Project: **GROSSE POINTE PUBLIC SCHOOL SYSTEM**
Richard Elementary School
Restroom Remodeling – Phase Two

Project No.: 9113

Addendum Number: 2

803 West Big Beaver Road, Suite 350, Troy, Michigan 48064 • 248.244.9710 • (f) 248.244.9712
email: architects@ehresmanassociates.com
© Ehresman Associates, Inc. 2016

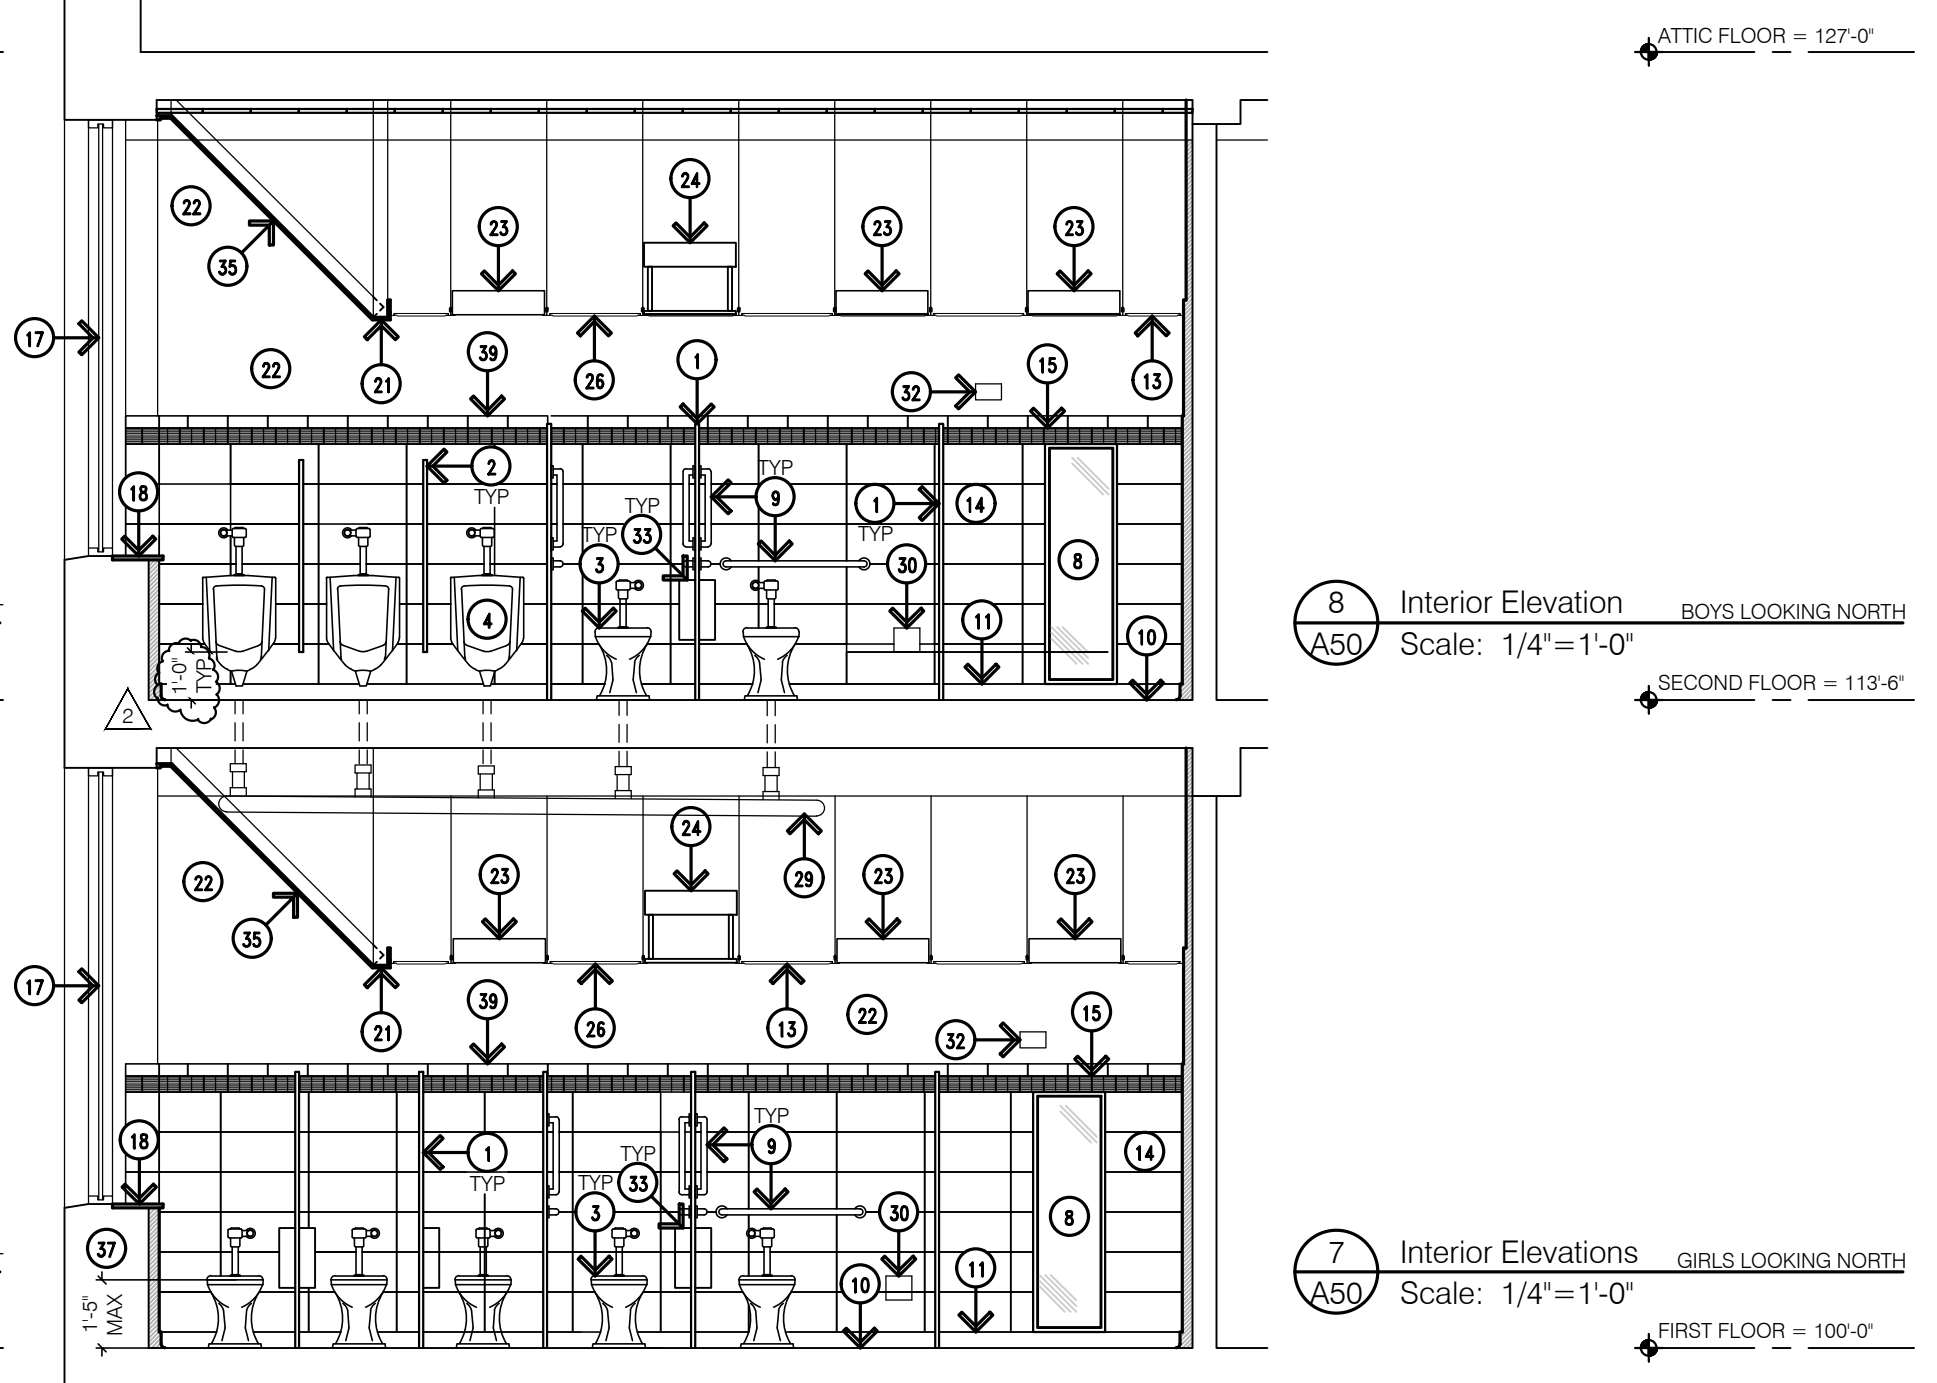
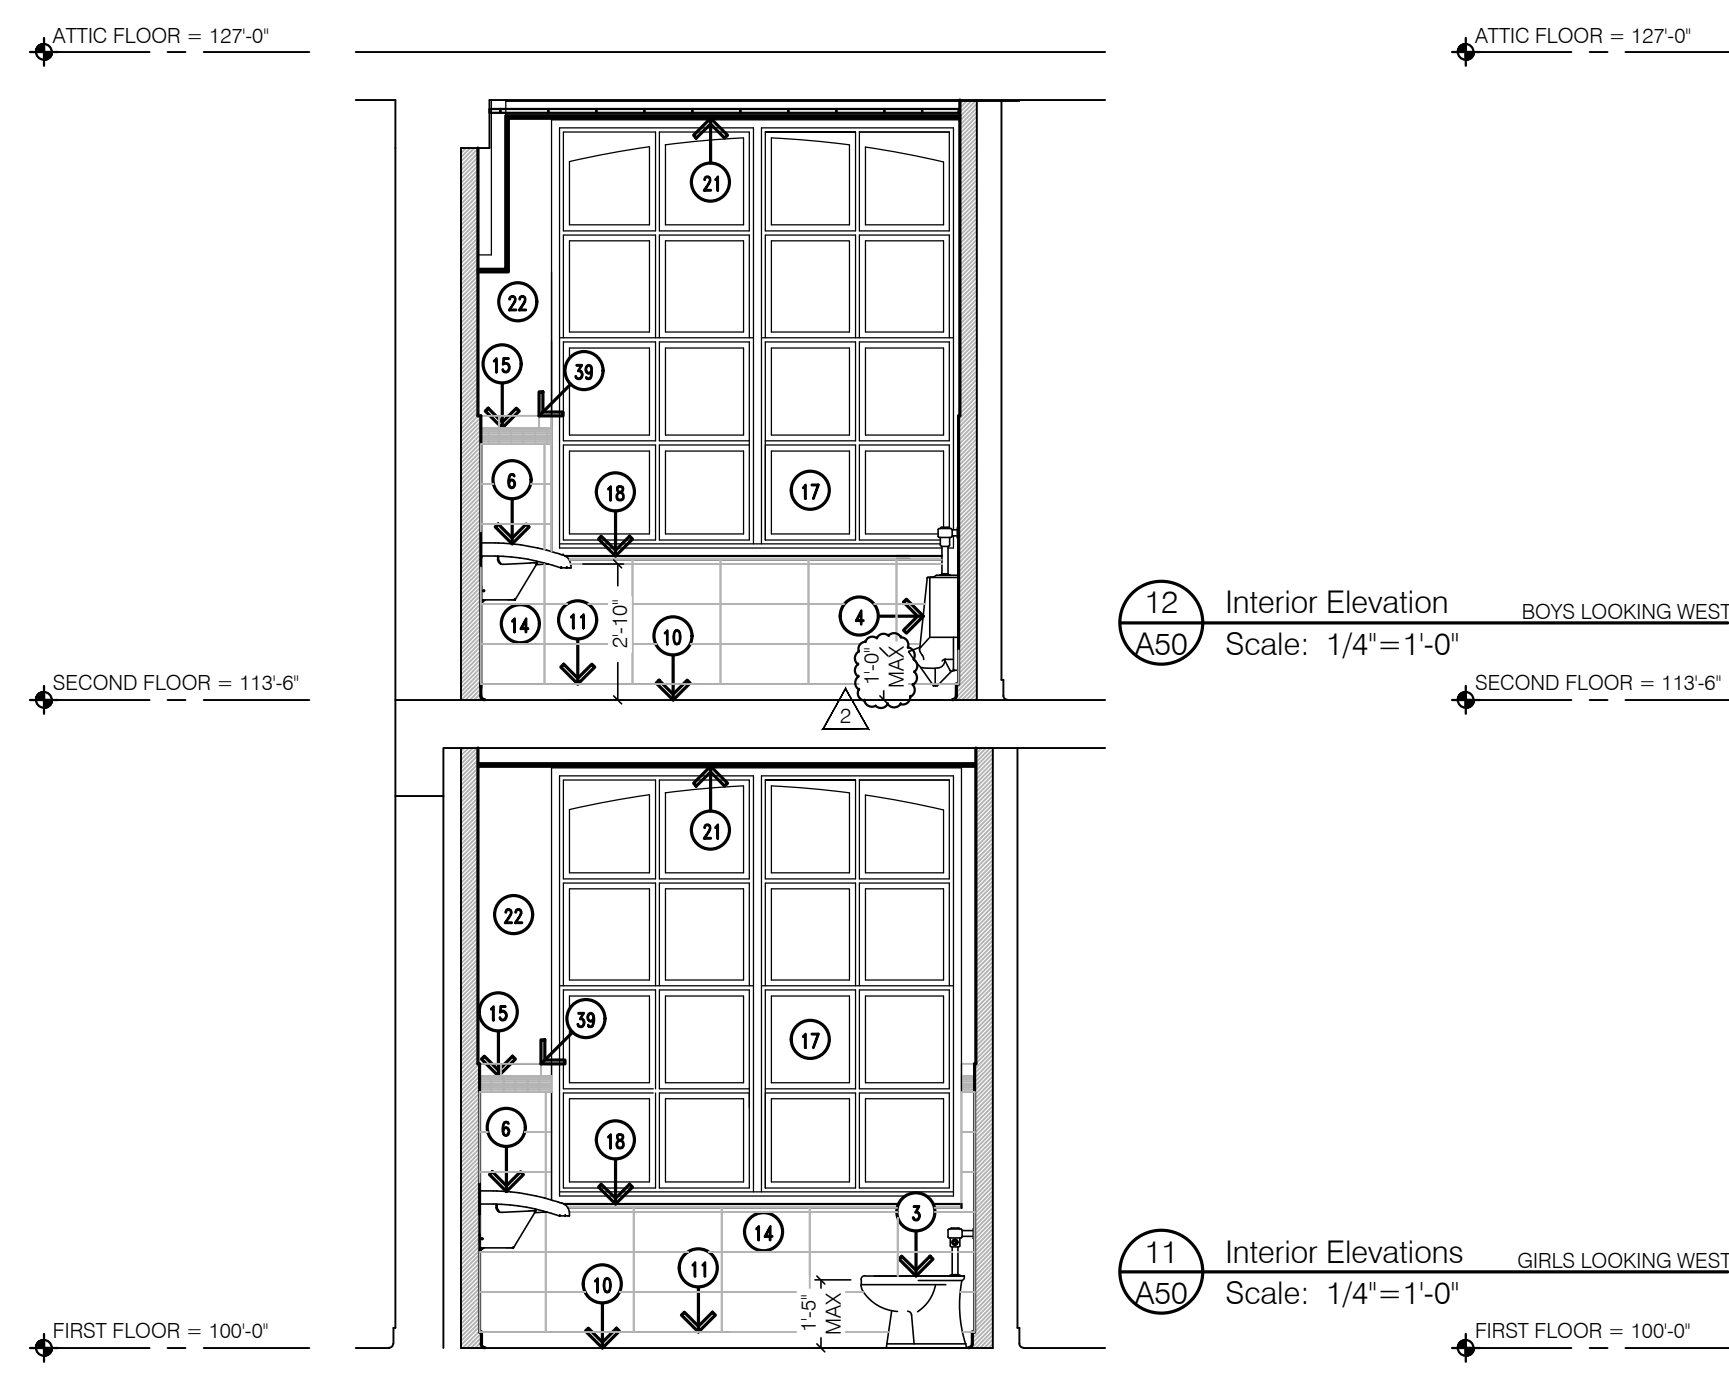
CHANGE: 3/A80. Urinal rim dimension.
FROM: 1'-5" Max
TO: 1'-0" Max

CHANGE: 8/A80. Urinal rim dimension.
FROM: 1'-5" Max
TO: 1'-0" Max
